**ASHLAND PLANNING DEPARTMENT**      **SITE:**                    822 Oak Street  
**PRE-APPLICATION CONFERENCE**      **APPLICANT:**      Rogue/Overlook  
**COMMENT SHEET**                              **REQUEST:**      PLA/MLP  
April 15, 2020

**PLANNING STAFF COMMENTS:**

Prototypical Section: Residential Neighborhood Street, Parallel Parking One Side

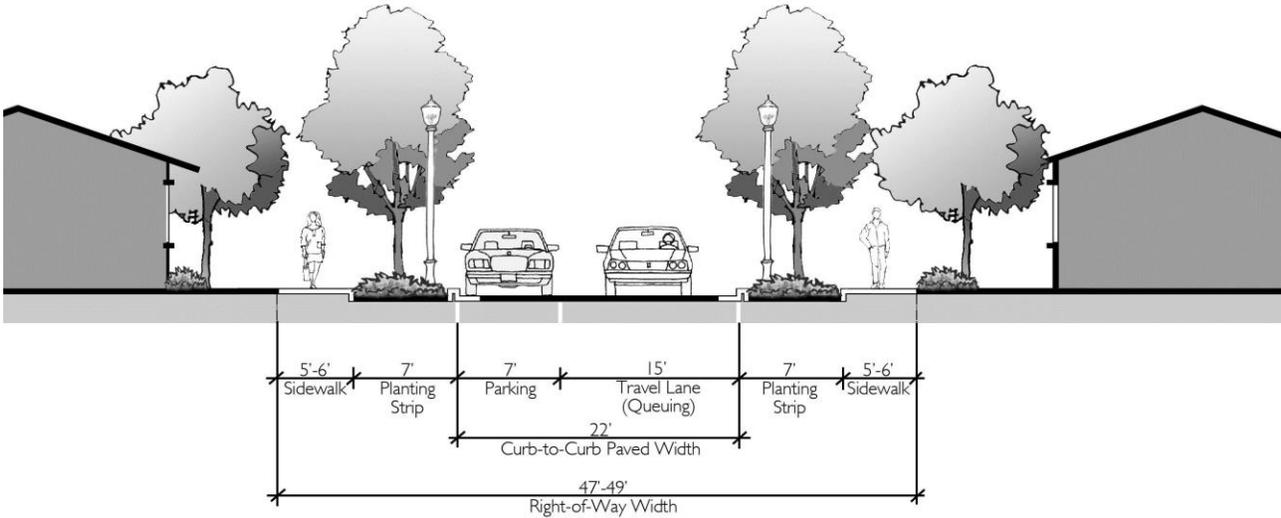
**New Street Dedication:** Generally, for a new street dedication a residential neighborhood street would be sought, and to accommodate required on-street parking the cross-section below with parking on one-side would likely be the most appropriate. *(Required on-street parking would not generally be compatible with a shared street cross-section.)*

Any exception from the standard cross-section would require an Exception to Street Standards.
